ADDENDUM NUMBER 2

**LINCOLN COMPLEX – BUILDING O O.A.R., LIBRARY SERVICES AND I.T.
RENOVATIONS
930-B Oak Street SE, Albuquerque, NM 87106
ALBUQUERQUE PUBLIC SCHOOLS**

APS RFP No. 21-031-RRR

Date of Issue: 12/7/2020

AD-102

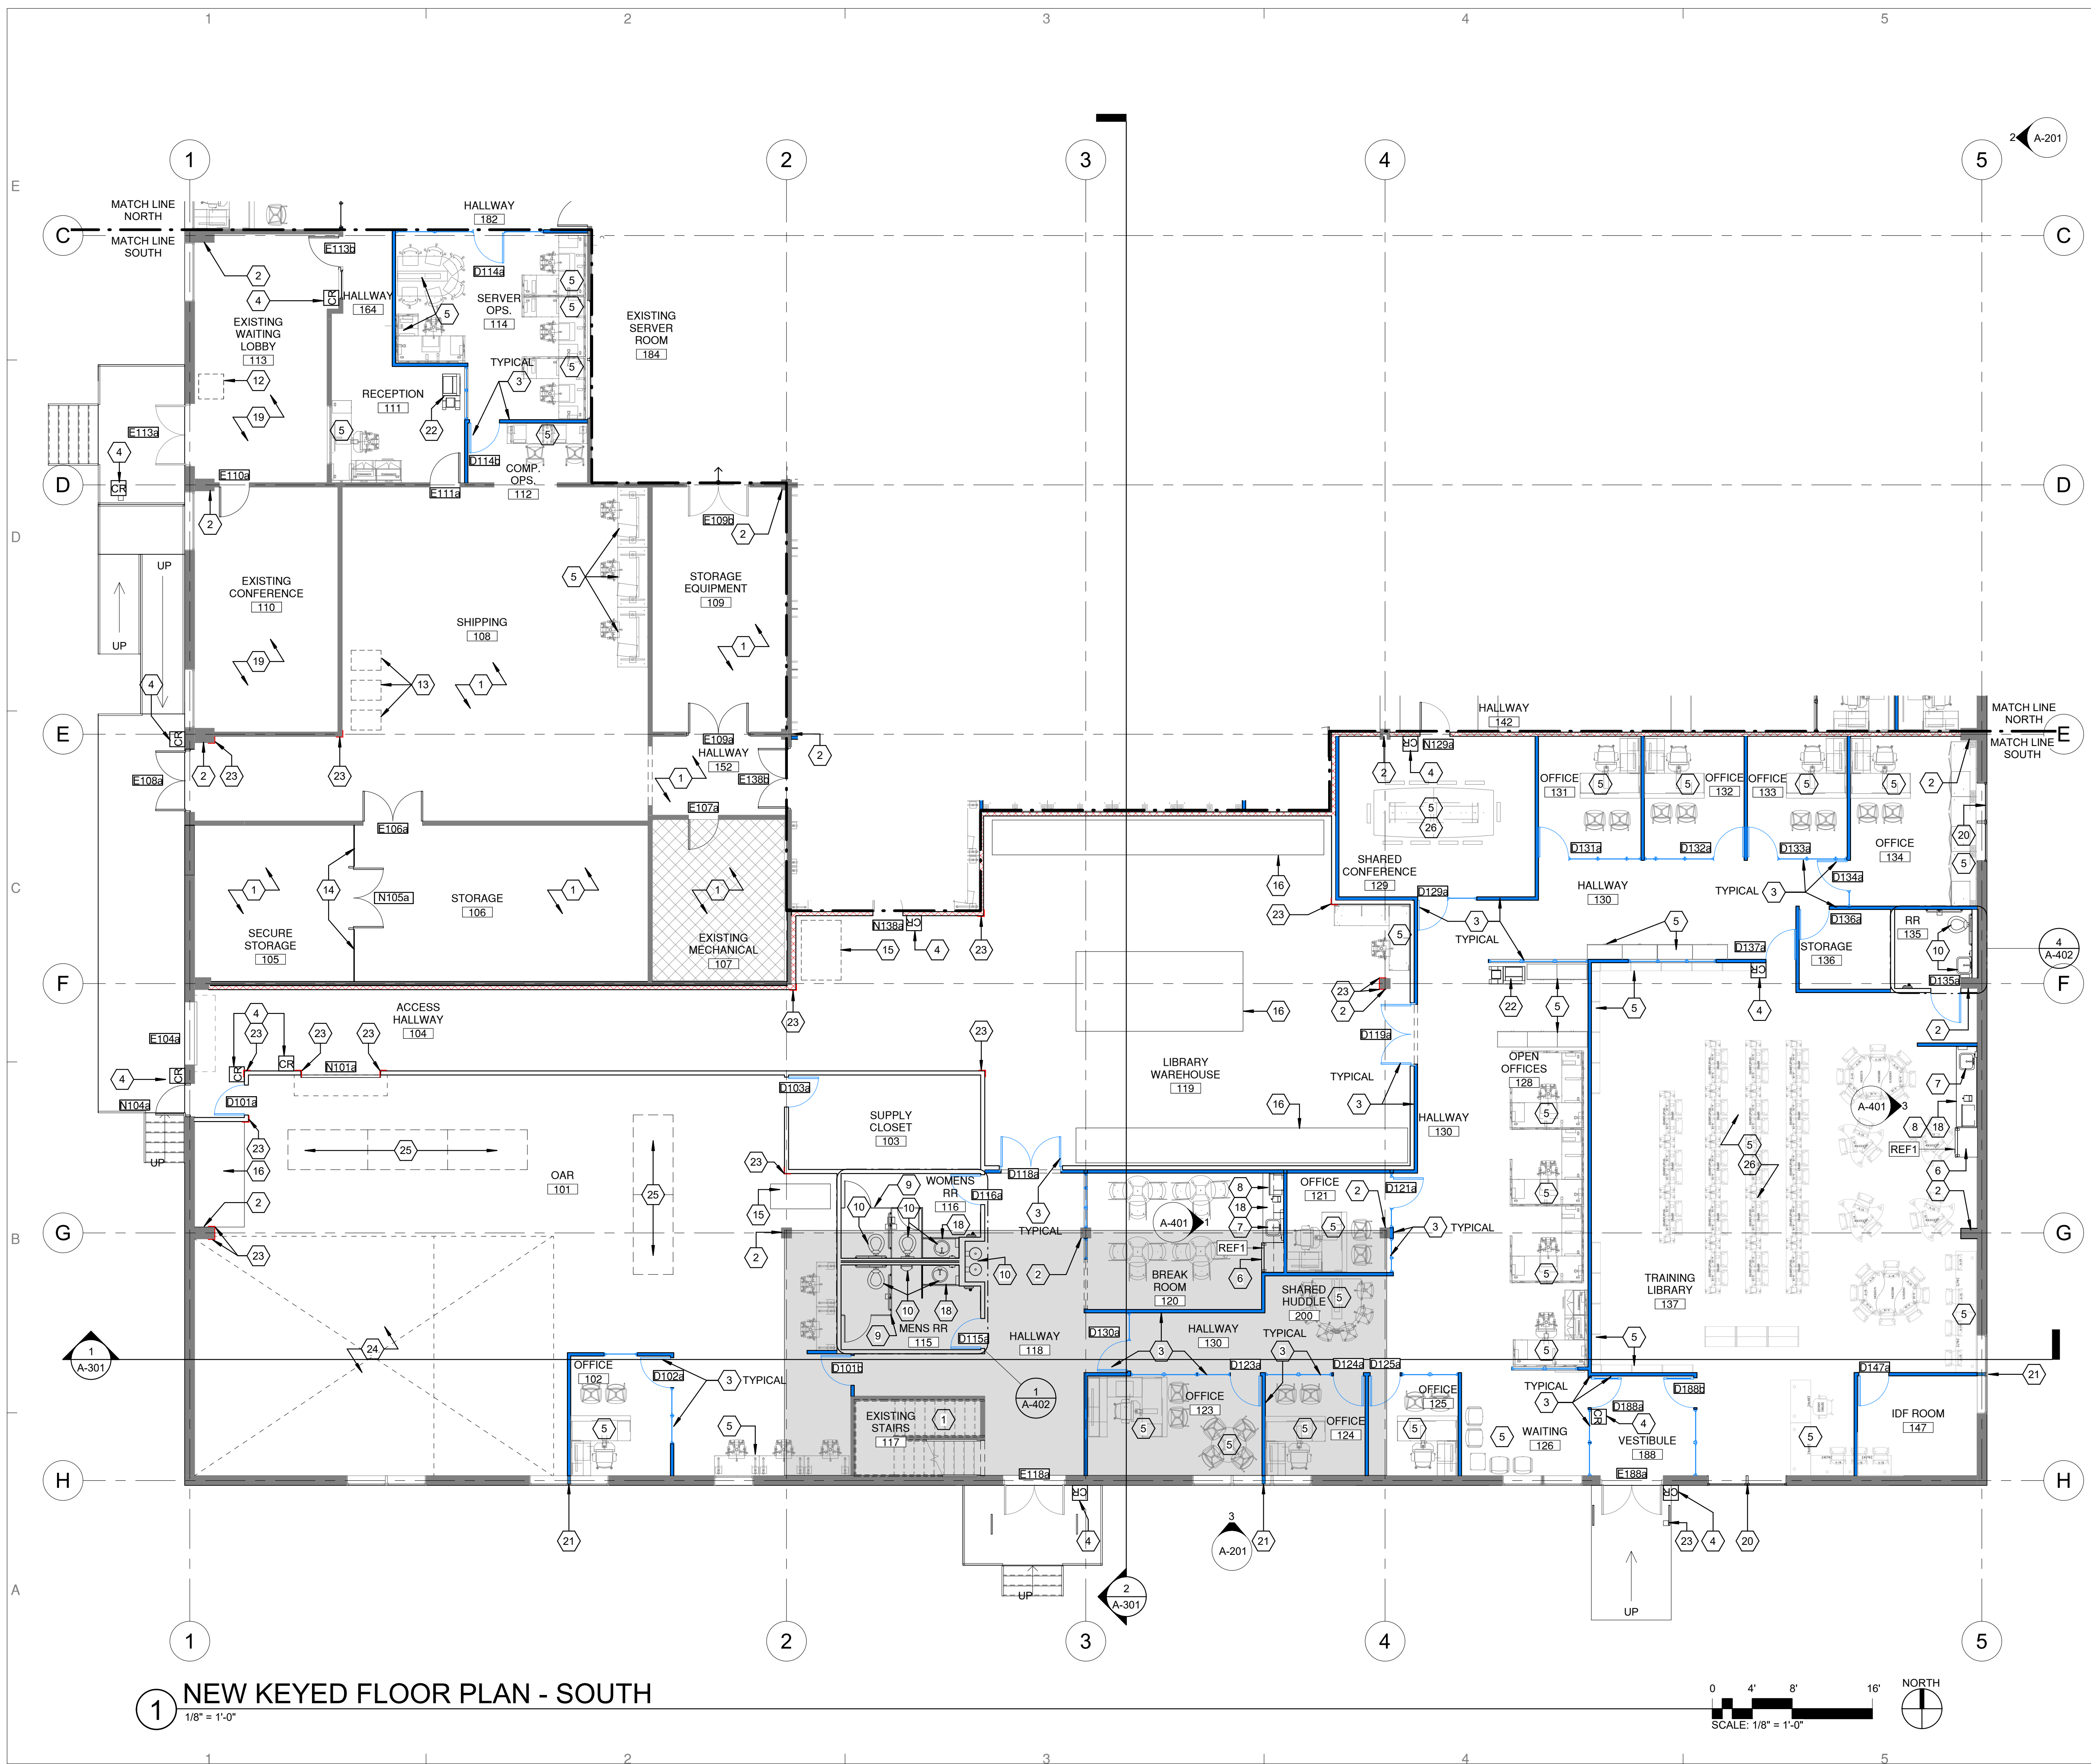
"Please describe vault construction to be demolished on AD-102."

Answer: The vault door is a true metal vault door and the vault is masonry construction.

A-105

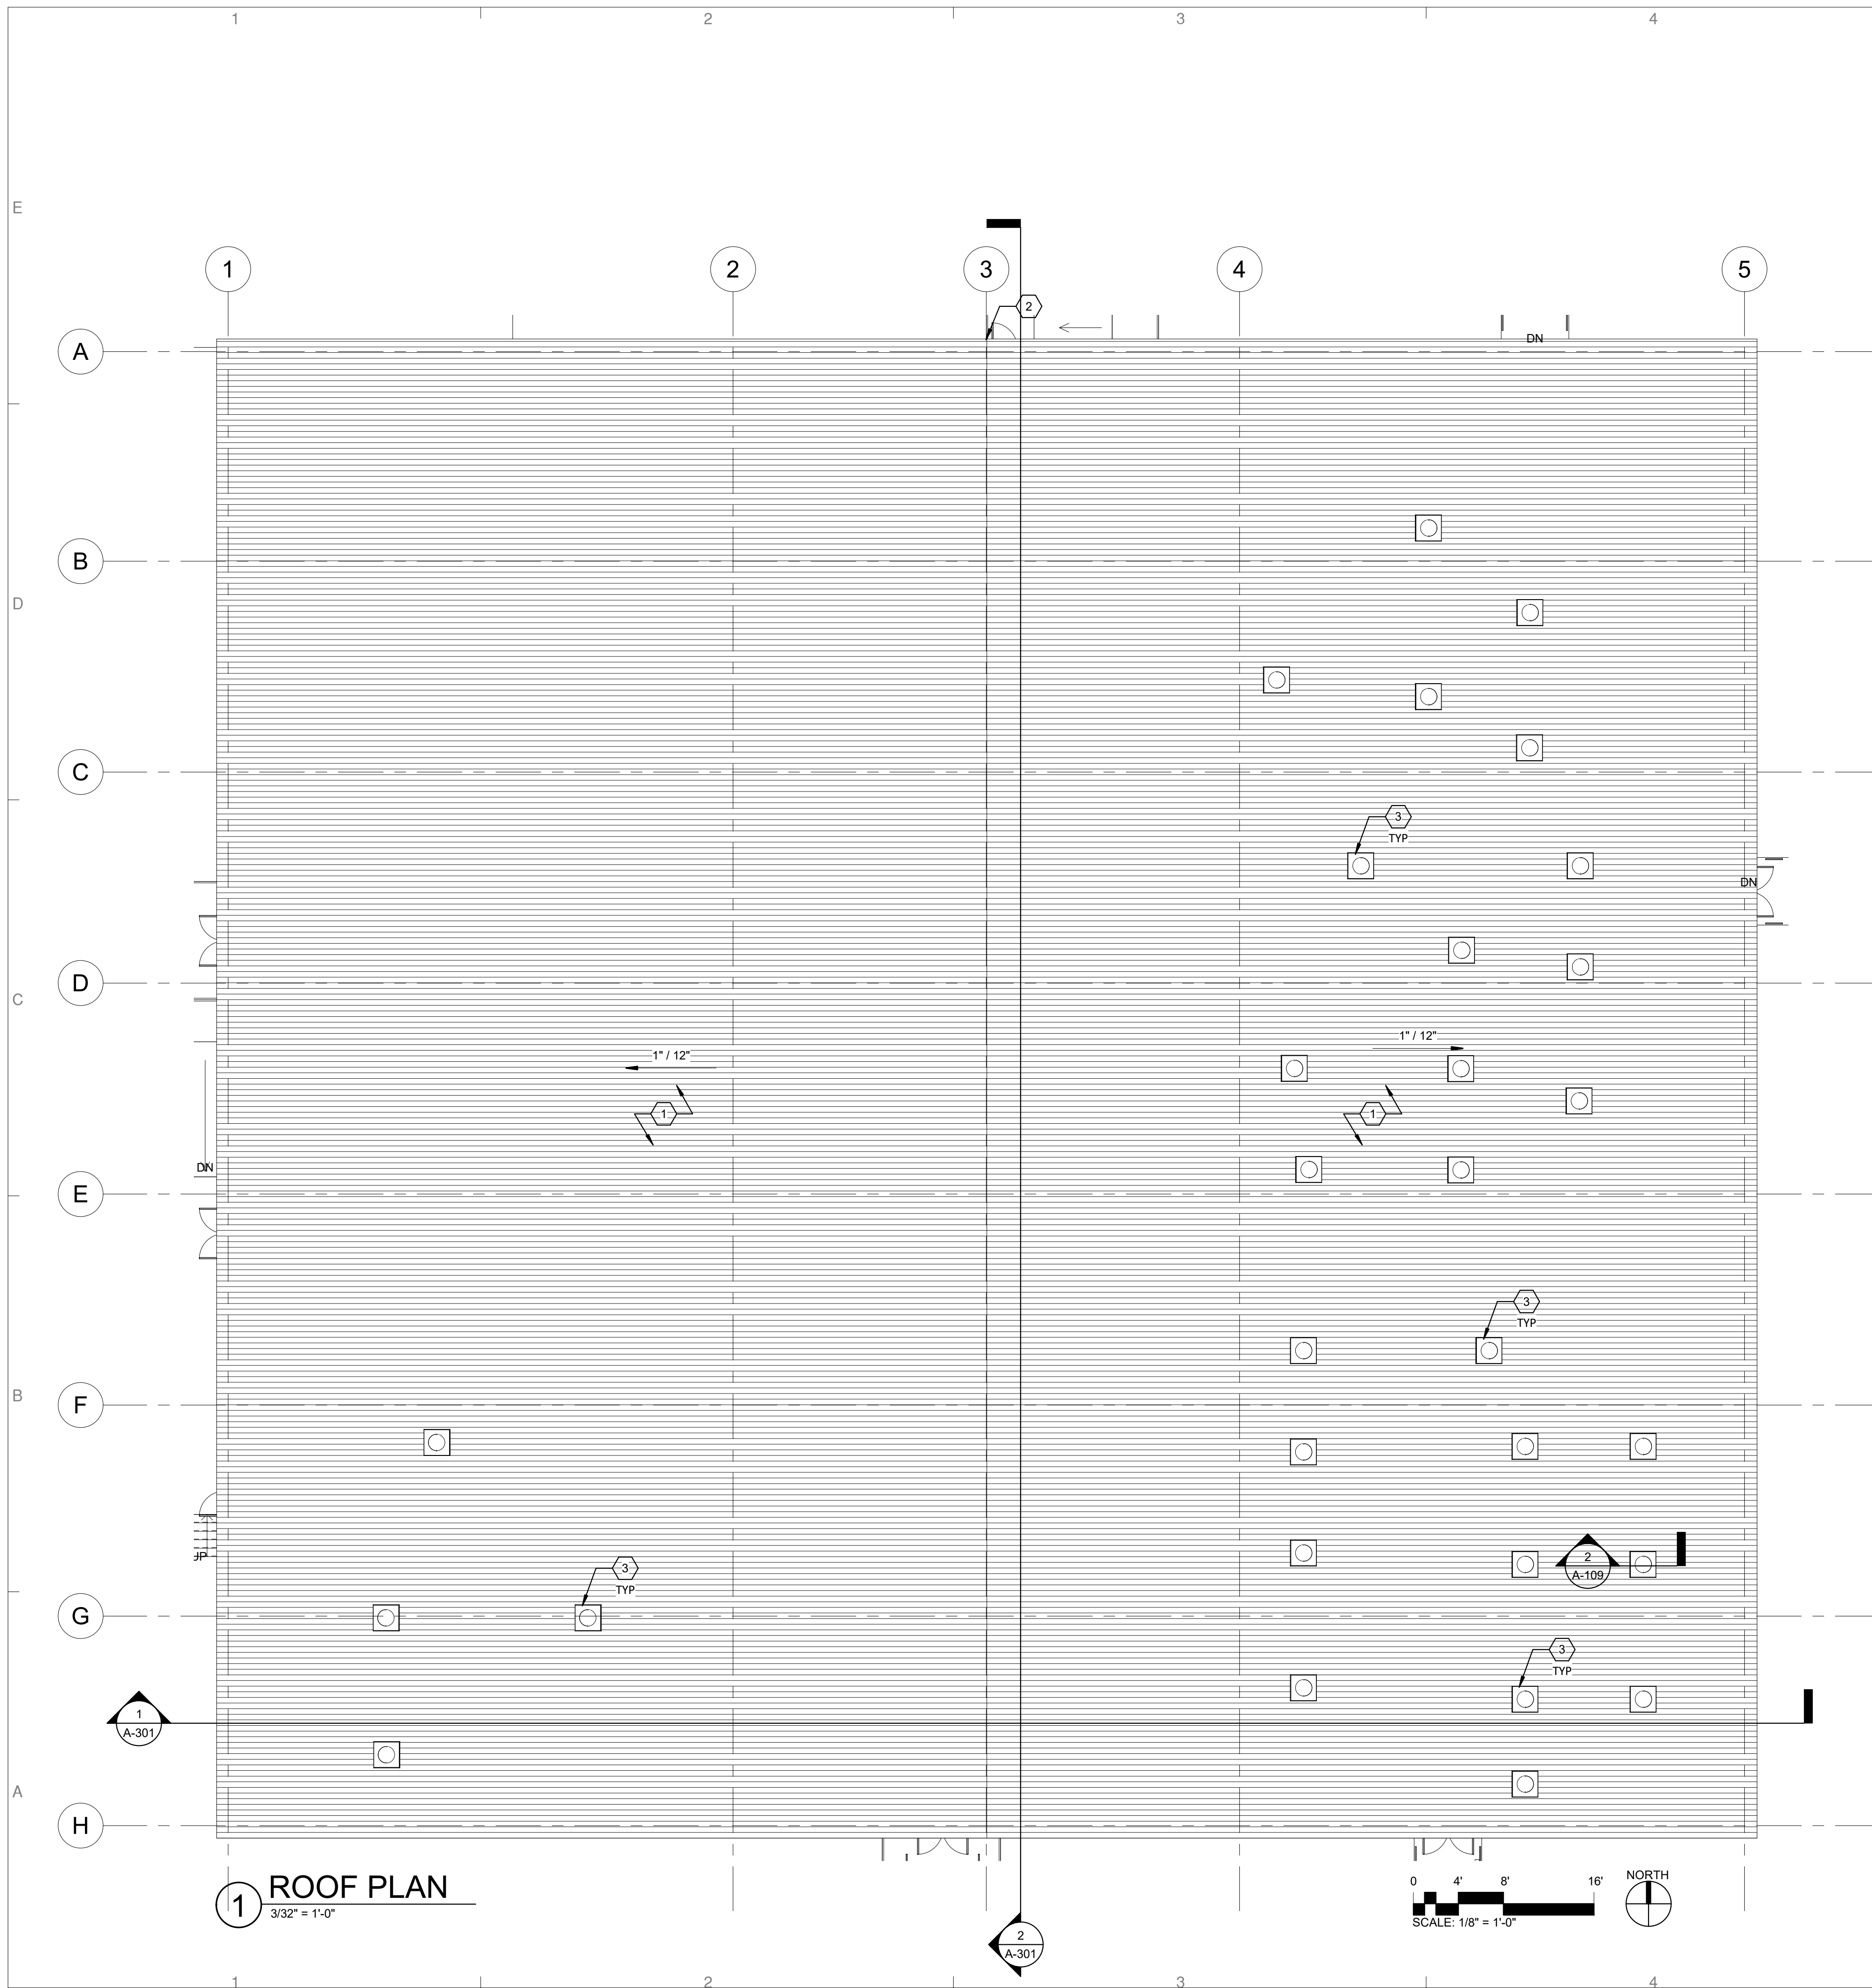
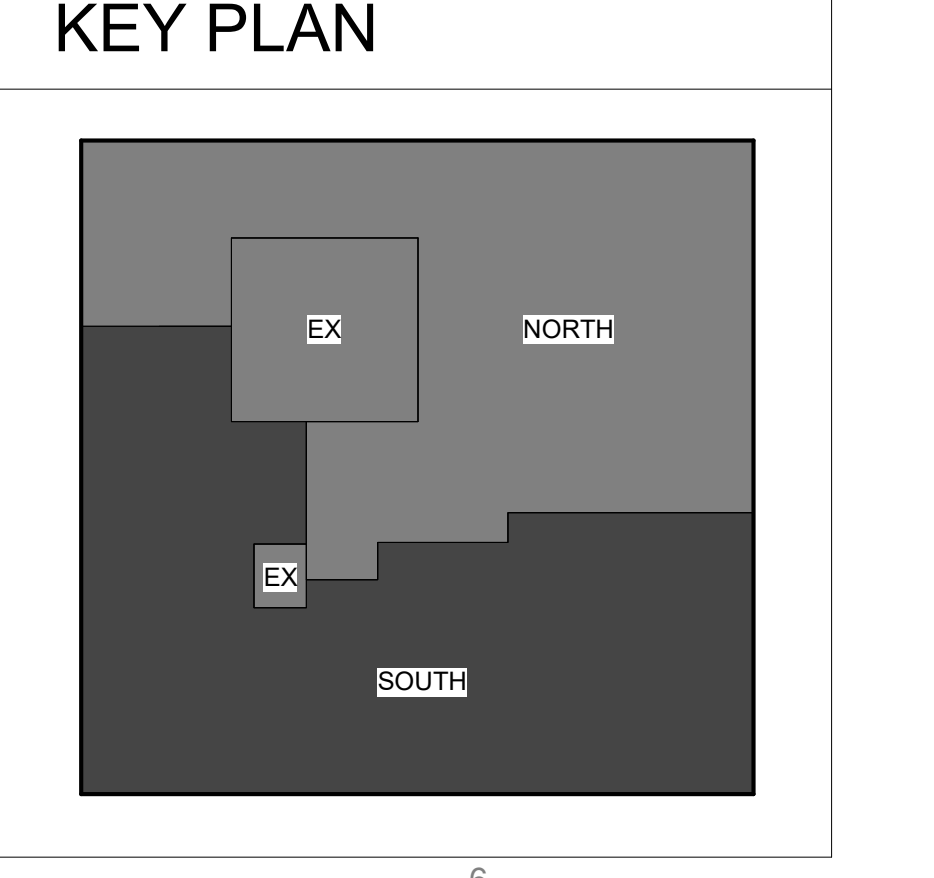
"Are any card readers on construction plans existing (Some are greyed out)?"

- 1) Add "Typ. Skylight Framing", Detail 3/A-109 for structural framing members and connection of tubular skylights to existing roof structure. See attached A-109 "Revision 1" sheet.
- 2) Clarification for stainless steel corner guards from keynote 23 on sheet A-105 New Keyed Floor Plan and sheet A-801 Finish Plan. Please see attached A-105 for corrected keynote 23 for the change of 8' stainless steel corner guards to 6' stainless steel corner guards to match legend sheet A-801 Finish Plan.
- 3) Clarification for Door Schedule on Sheet A-601 and Door Types on Sheet A-602. See attached A-601 "Revision 1" and attached A-602 "Revision 1" for changes to Door Type "E" and Door Type "F" to now match on both sheets.

Answer: All card readers are to be new. Please refer to New Keyed Floor Plans A-105 and A-106. The construction plans call out wall types for wall construction. Please refer to electrical drawings as well for related work.
